Planning Commission Meeting Agenda
Hartland Township Hall
Thursday, November 17, 2022
7:00 PM

Hartland Township Planning Commission Meeting Agenda Memorandum

Subject: Site Plan with Special Land Use Application #22-015 (Mini warehouse establishment with outdoor storage as accessory to a permitted use)

BUILDING #04 - WEST ELEVATION

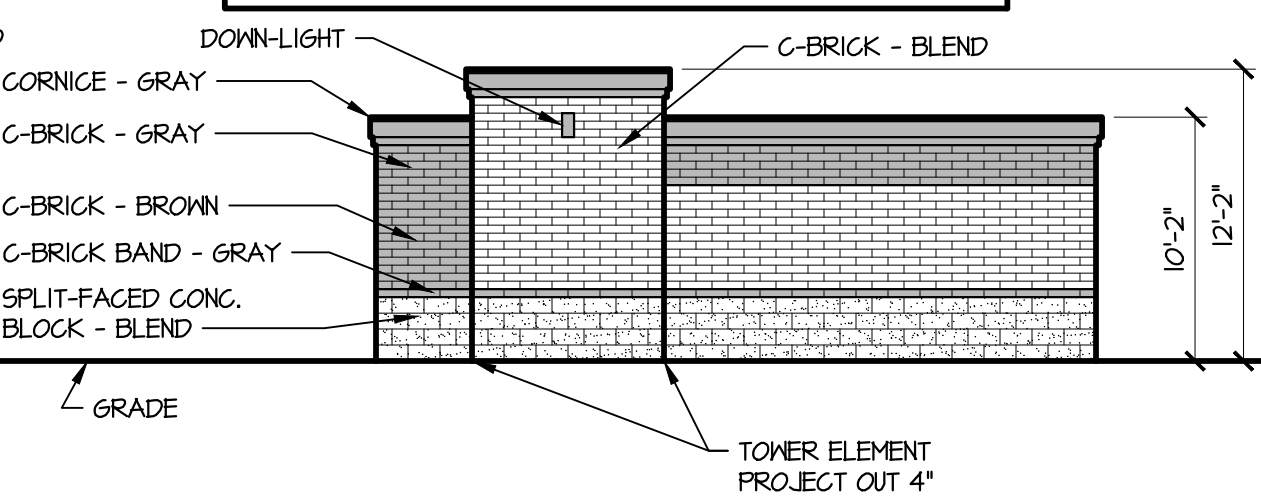
*Staff assumes the information listed for Building #4 on Sheet A2 has flipped the façade material information for the east and west end walls, as the east end wall faces US-23 and would have masonry products, and the west end wall is interior to the site and may have 1-3 garage doors/ribbed metal panels.
